**PLANNING, ZONING, & BUILDING DEPARTMENT**  
**PZ&B Staff Combination Memorandum: Town Council and Landmarks Preservation Commission**

**SUBJECT:** HSB-23-009 (ZON-23-111) 269 PARK AVE (COMBO)

**MEETING:** NOVEMBER 17, 2023 LPC  
DECEMBER 13, 2023 TC

**HSB-23-009 (ZON-23-111) 269 PARK AVE (COMBO) AND FLOODPLAIN VARIANCE.**

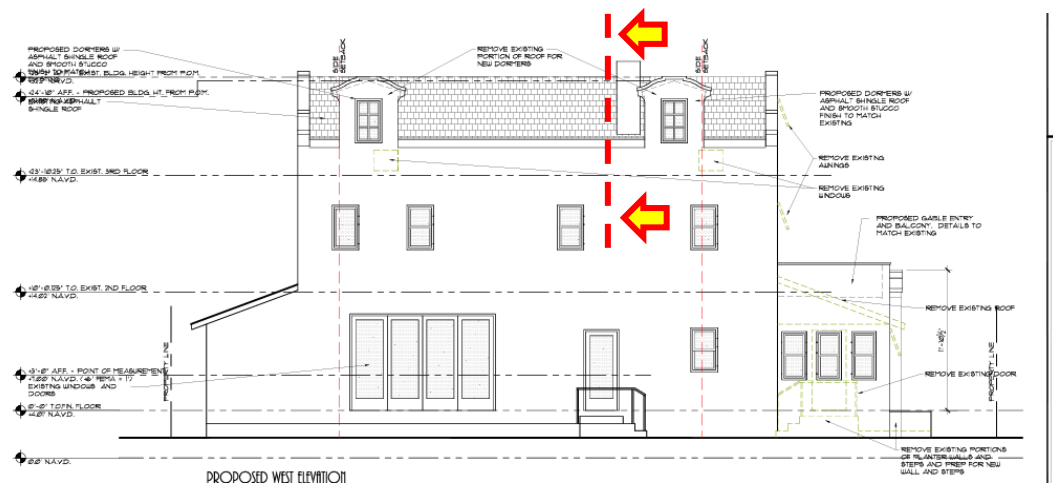
Staff will note that through the design review process, the applicant modified the proposal as originally presented to staff and moved the two front dormers further back from the street between First and Second Submittals as depicted below:

The Town's historic preservation consultants maintain that the installation of four new dormers, with two being located towards the front of the building, is not appropriate and is unnecessary for the proposed storage space use. One larger dormer, centrally located on the east and west facades, would provide natural light, egress if needed, and greatly minimize the visibility from the street.

Alternatively, staff is amenable to exploring a further step back behind the existing chimney, as depicted above, for the two southernmost front dormers. Otherwise, with the elimination of two of the four dormers, staff is supportive of Variances 2 and 3.

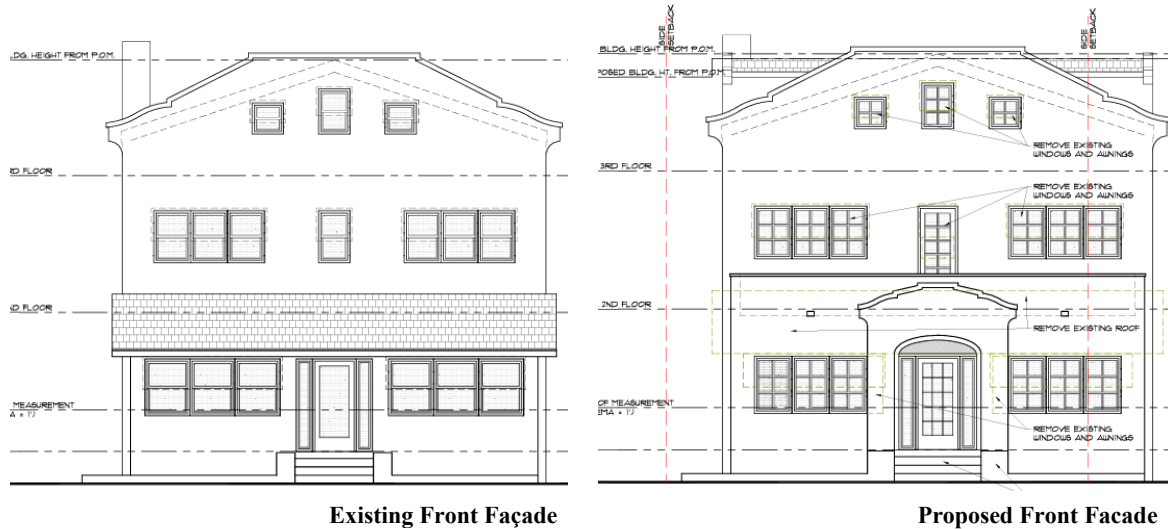
In addition to Variances 2 and 3, Variance 4 involves the location of the two **east side** dormers, which are in the required setback. Although the property was constructed prior to the current zoning code and has an established non-conforming side setback of 5'-5", today's code requires a side setback of 10'-0" for single family structures. As such, the vertical extension of the east wall for the construction of the dormers requires a variance. This variance also extends to the new terrace above the front porch (see analysis below) with a 5.9' foot side setback.

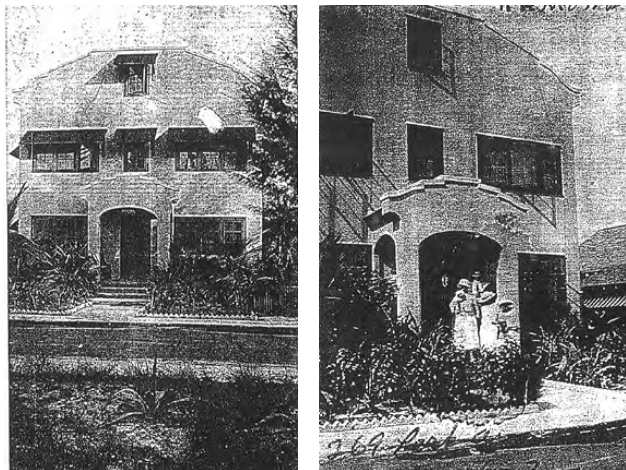
The architectural improvements to the primary façade include the construction of a gabled covered entry which is closer to the street than currently permitted and will further exacerbate the existing non-conforming front setback by bringing a portion of the front entry 1'-0" closer. Staff is highly supportive of the chosen design, which incorporates a feature that is evocative of the original entry. The 1927 permit and drawings that are presented as evidence of the front addition are likely of the rear addition, as the floor plan shows the entry door in an off-center location and notes that it contains kitchen features such as a stove, sink, and icebox. There is not a building permit located in the Town's Microfiche records that provide a date for the addition, however, it

was likely a very early addition. Staff recommends that the sidelights at the front door have divided lites to match the window and door design of the main façade, as typical for the period of construction. Staff is supportive of the setback variances (4 and 5) as it pertains to the revised front entry feature.
